## ADDENDUM NO. 06

13 April 2010

Project: **A NEW TRANSPORTATION FACILITY**  
Dickinson Independent School District

Bay Project No.: **0806**

### C1.00-SITE DEMOLITION PLAN

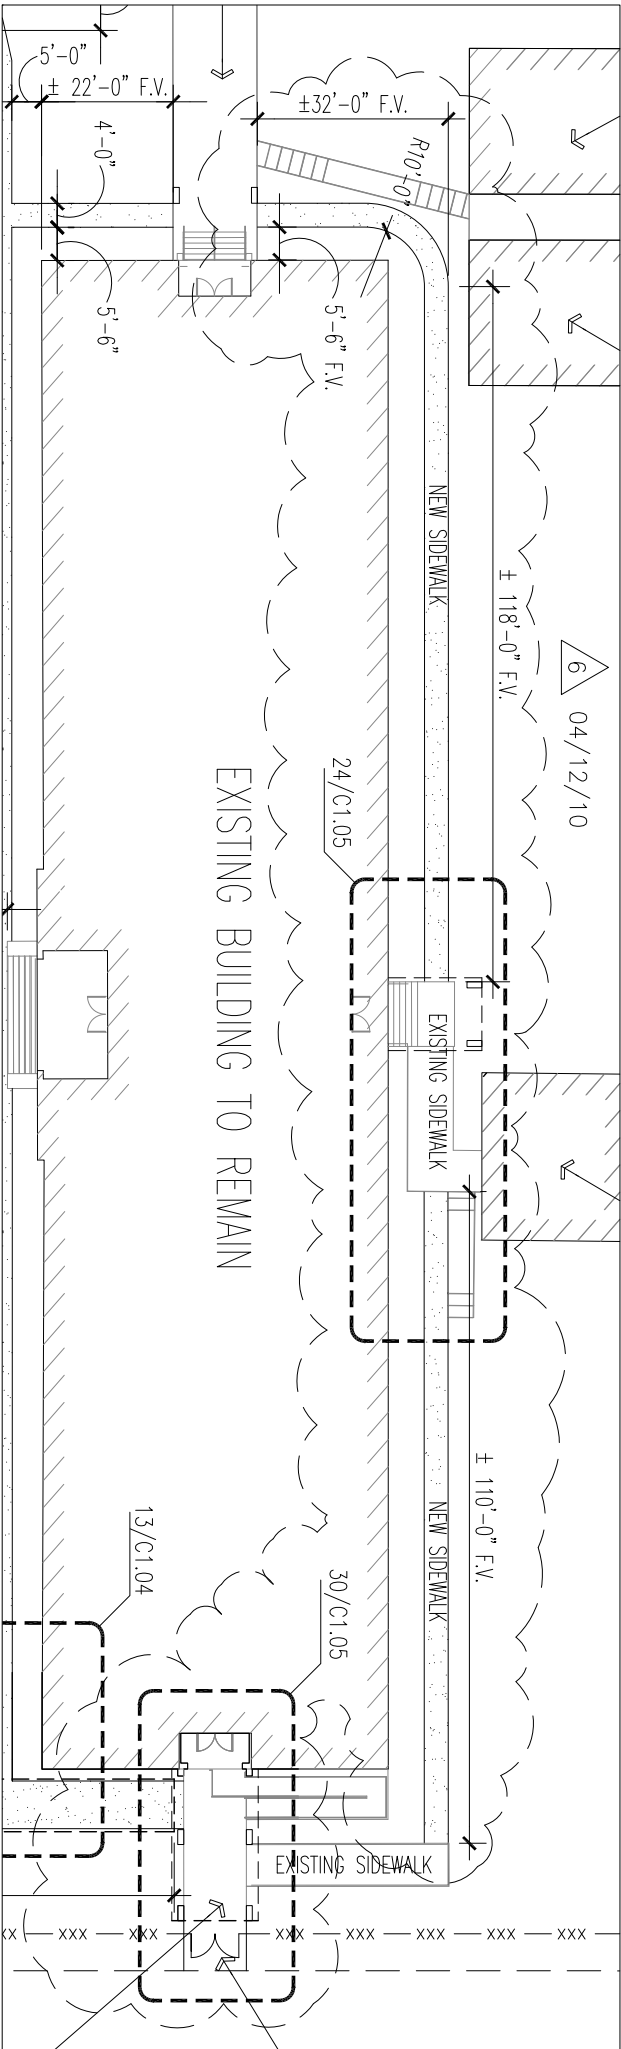
11. Sheet C1.00 Site Demolition Plan: Revise sheet scale 1 Site Demolition Plan to read 1” = 60’-0”
12. Sheet C1.00 Site Demolition Plan: Demolish entire sidewalk north of existing “H” building and install new sidewalk to be configured as shown on sketch **ADD-06-01**.

### 6/C1.02-ENLARGED SITE PLAN

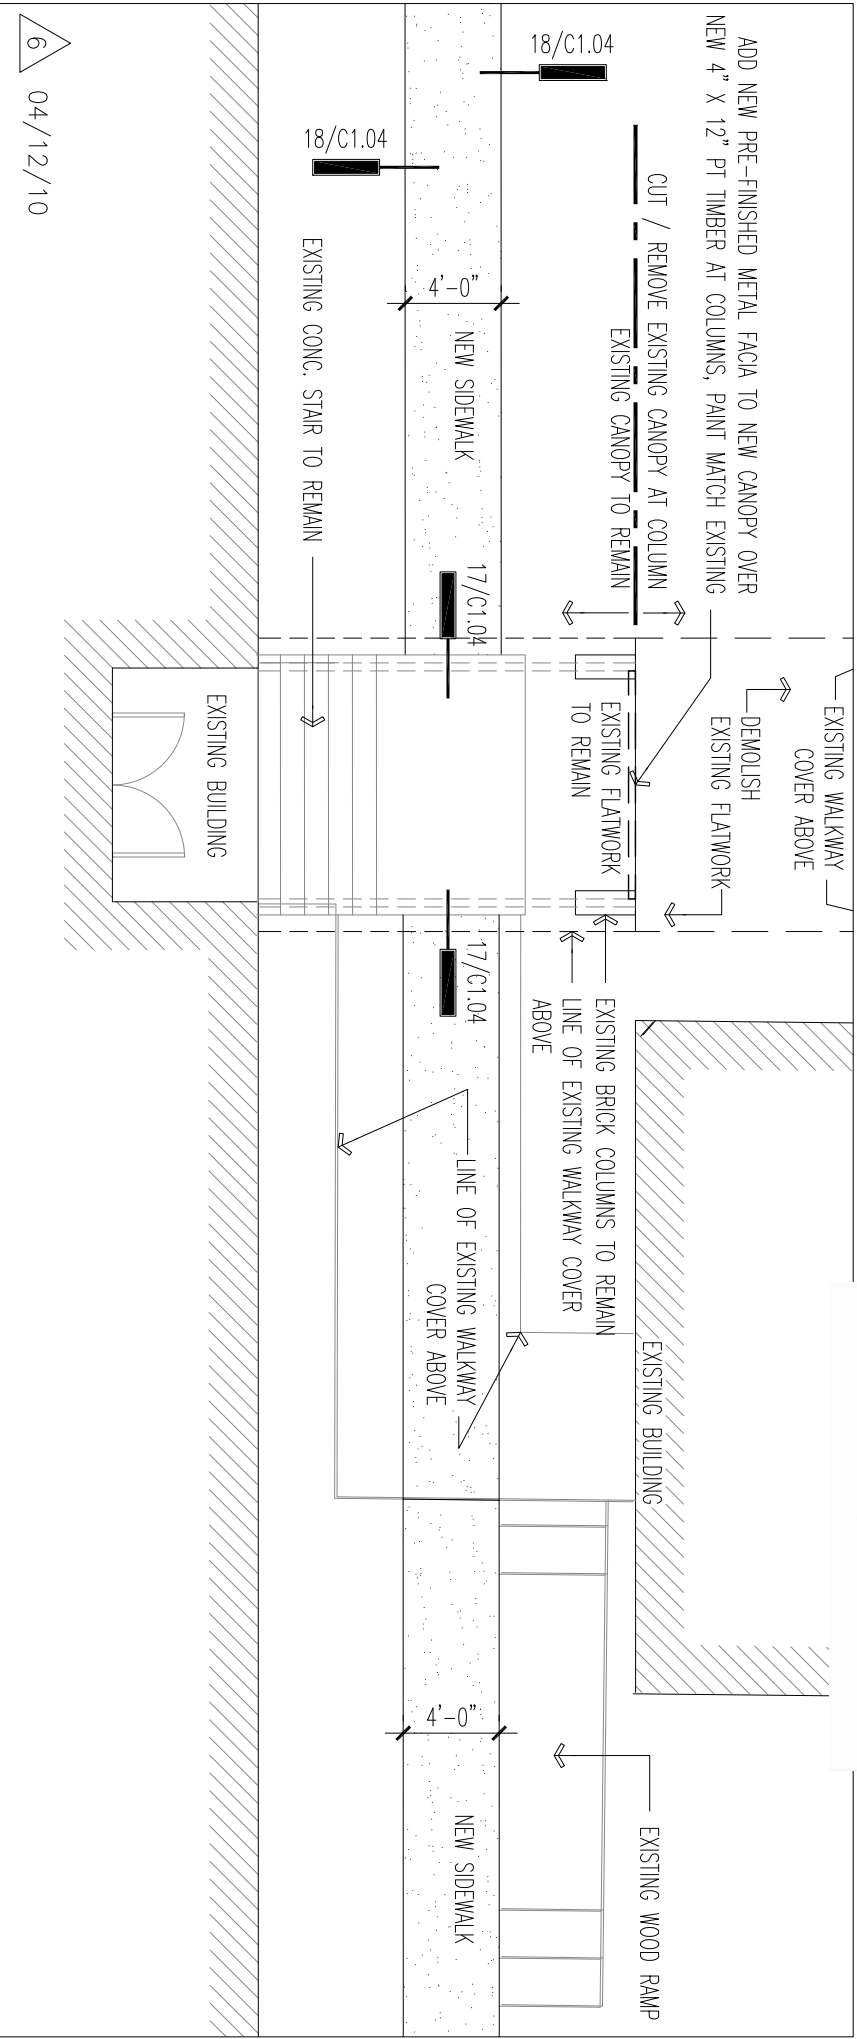
13. Sheet C1.02: Revise Sheet name to “C1.02- Enlarged Site Plan North”
14. Sheet C1.02 Enlarged Site Plan North: Revise Enlarged site plan as shown **ADD-06-01**.

**30/C1.05 - ENLARGED SITE PLAN**

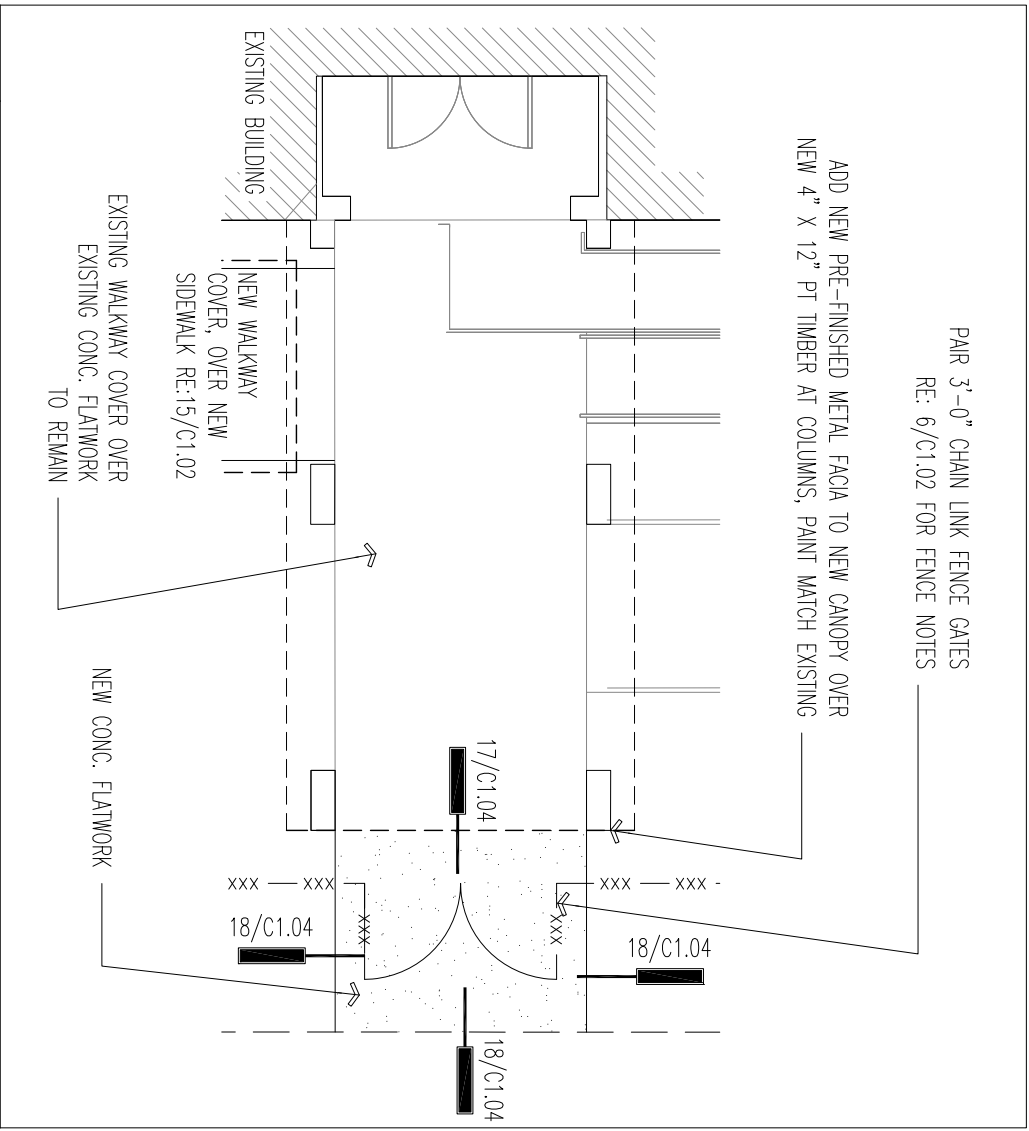
17. Sheet C1.05 Enlarged Site Plan and Details: Add Detail 30/C1.05- Enlarged Site Plan as shown on sketch **ADD-06-03**.
18. Sheet A2.01 Floor Plan Transportation Building: Provide window in room 108/112 as shown sketch **ADD-06-04**.

# WINDOW ADDITIONS AND REVISIONS

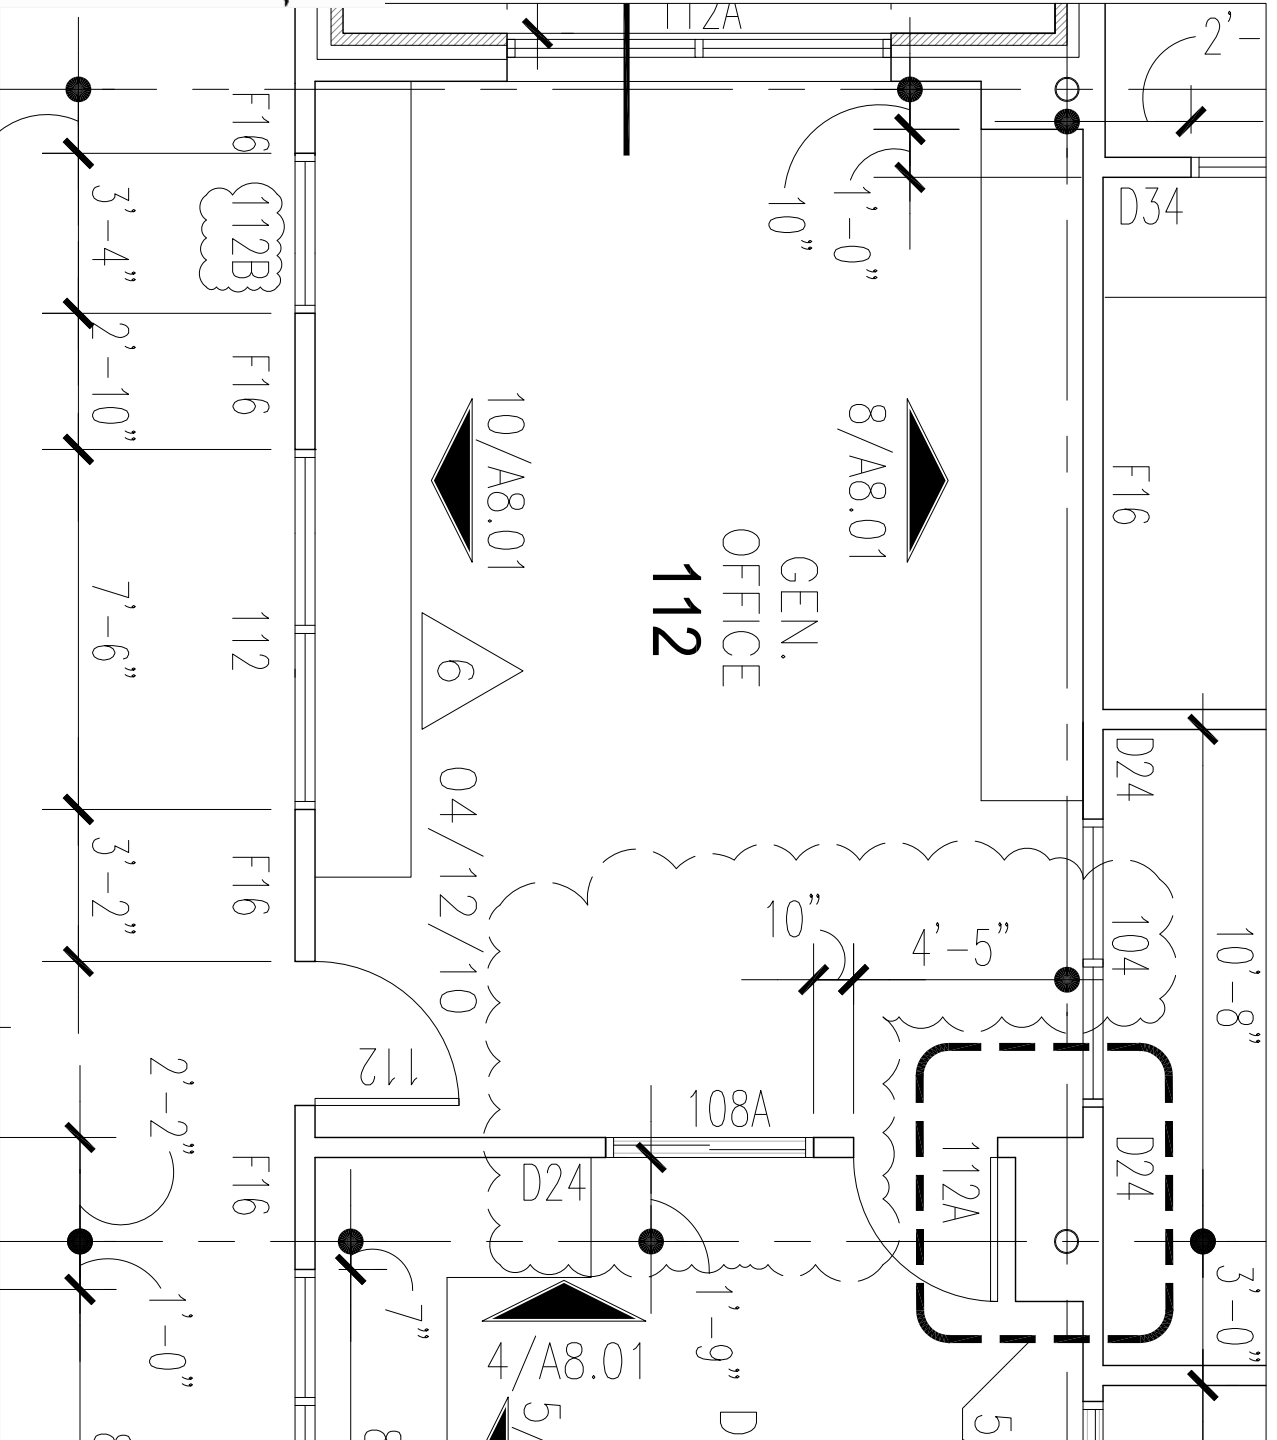
19. Sheet A2.01 Floor Plan Transportation Building: Revise window in Southwest corner of Room 112 to read “ 112B “ as shown on sketch **ADD-06-04**.
20. Sheet A2.02 Finish, Door, and Window Schedules Transportation Building: Door Schedule- delete door 121A

# WINDOW ADDITIONS AND REVISIONS

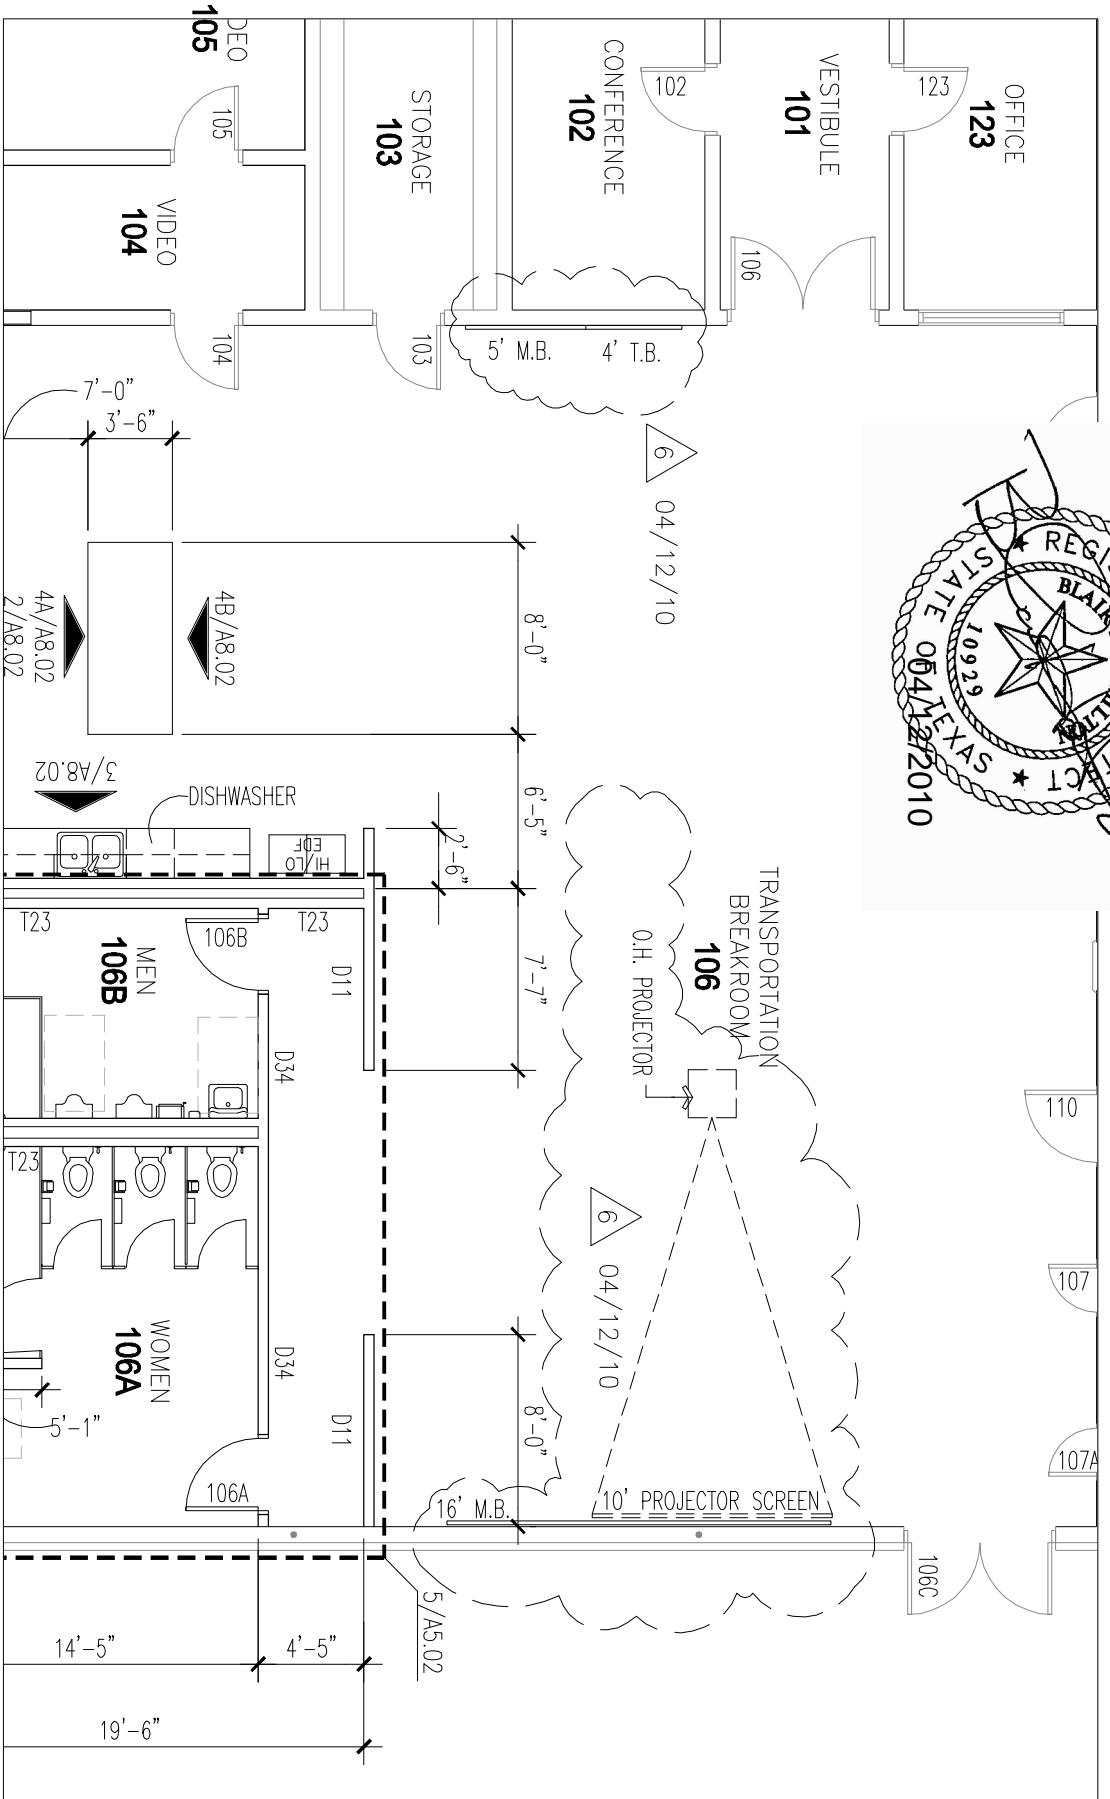
21. Sheet A2.02 Finish, Door, and Window Schedules Transportation Building: Window Schedule- Revise window identifications as shown on sketch **ADD-06-05**.

# 3/A2.04-FLOOR PLAN TRANSPORTATION SUPPORT BUILDING

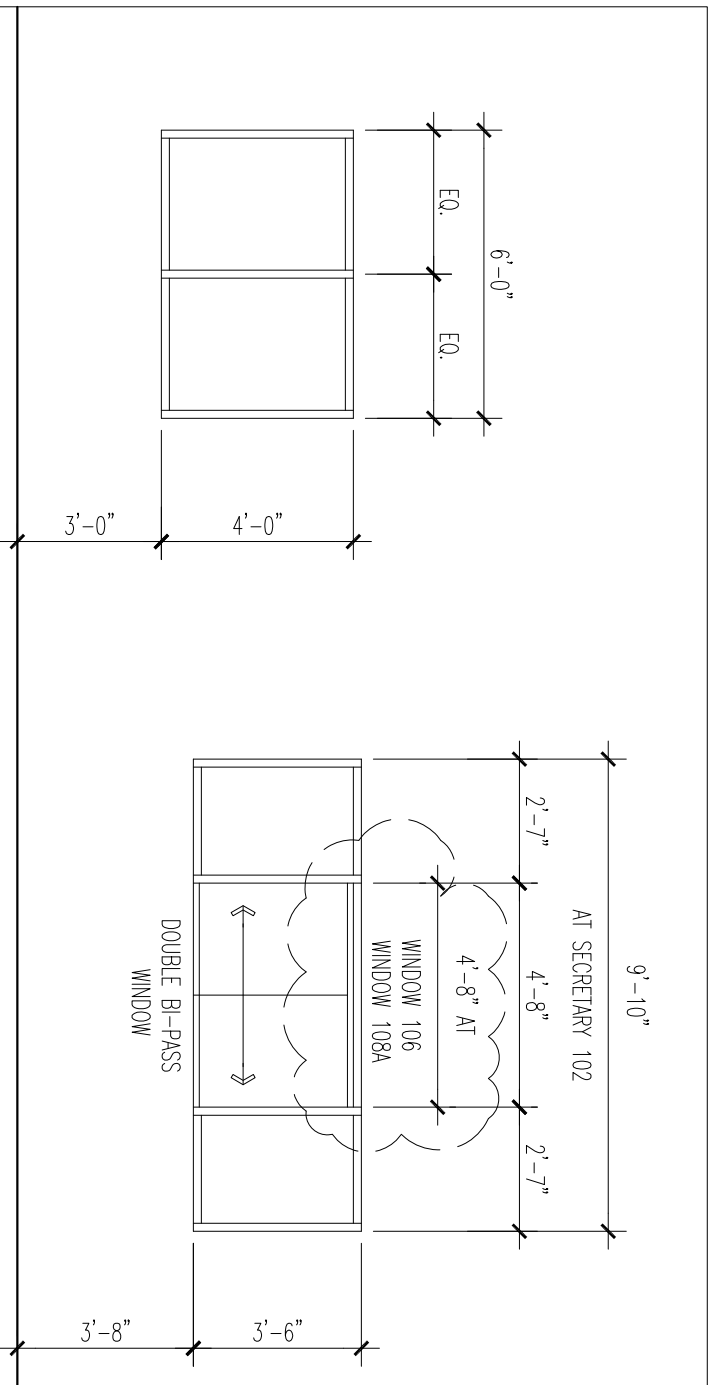
22. Sheet A2.04 Transportation Support Building: Add marker-boards, tack-board, overhead projector, and overhead projector screen as shown on sketch **ADD-06-06**.
23. Sheet A9.01 Door and Window Details: Revise window elevations as shown on sketch **ADD-06-07**.
